**1st AMENDMENT TO THE
ERCOT STANDARD GENERATION
INTERCONNECTION AGREEMENT**

LCRA Transmission Services Corporation

Grape Creek Wind, LLC

August 22, 2019

Exhibit "C2" **One Line Diagram – TSP Interconnection Facilities, Generation Interconnection Facilities and the Plant**

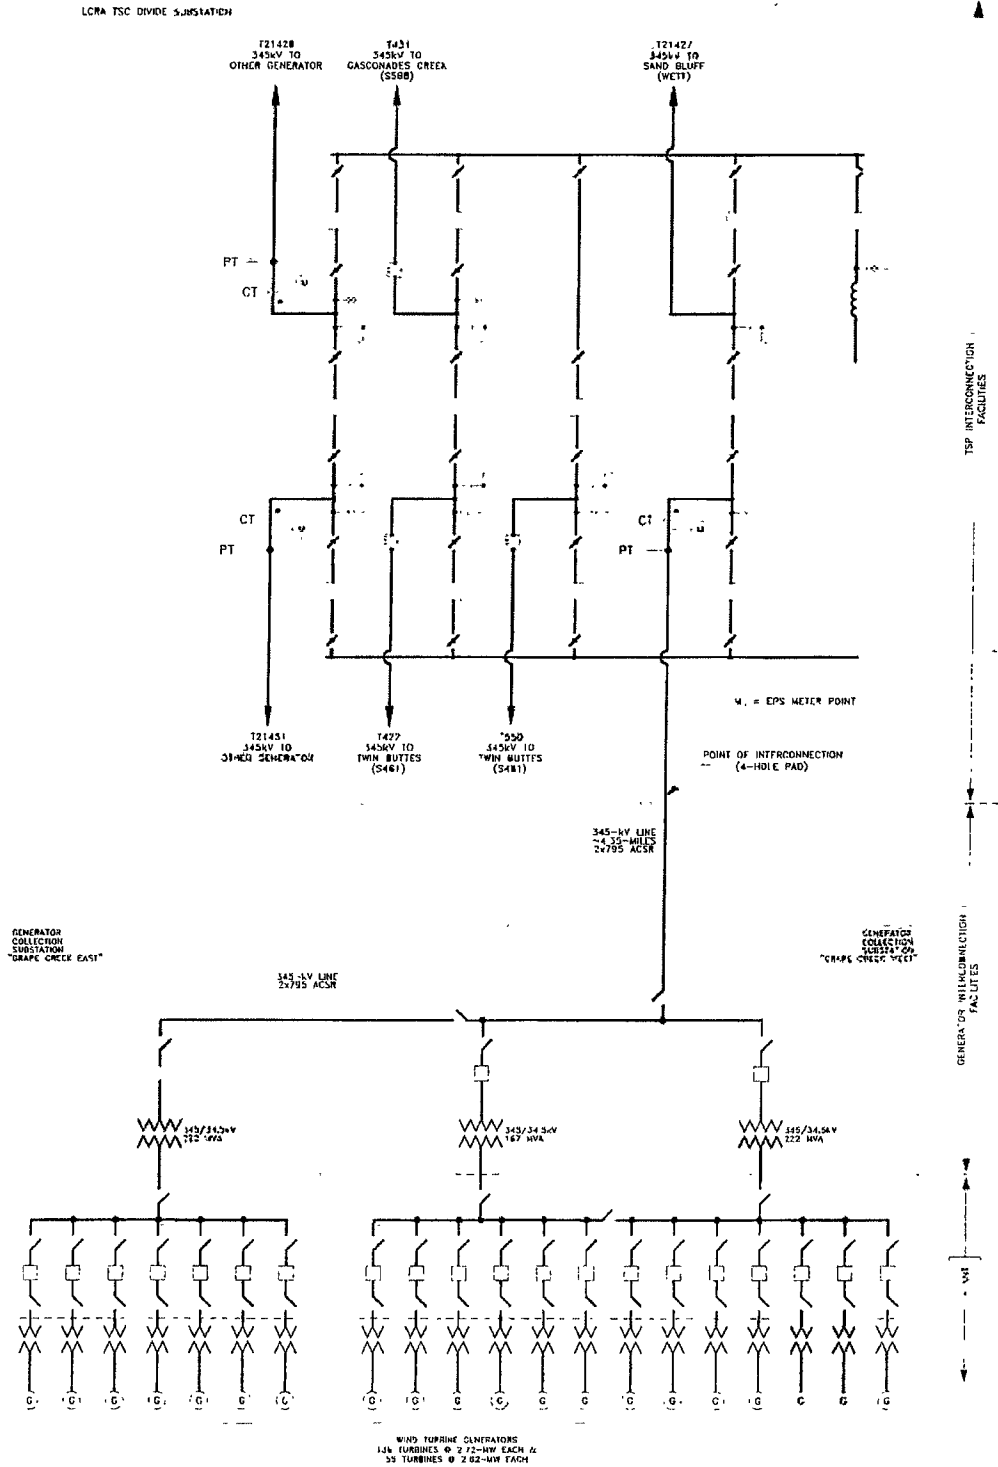
WHEREAS, Generator notified TSP of a change in the design of the Plant as originally contemplated in the Agreement.

1. Exhibits "B", "C", and "C2" are deleted in their entirety and the Exhibits "B", "C", and "C2" attached to this Amendment are hereby added to the Agreement in lieu thereof.
2. This Amendment will become effective upon execution by the Parties.
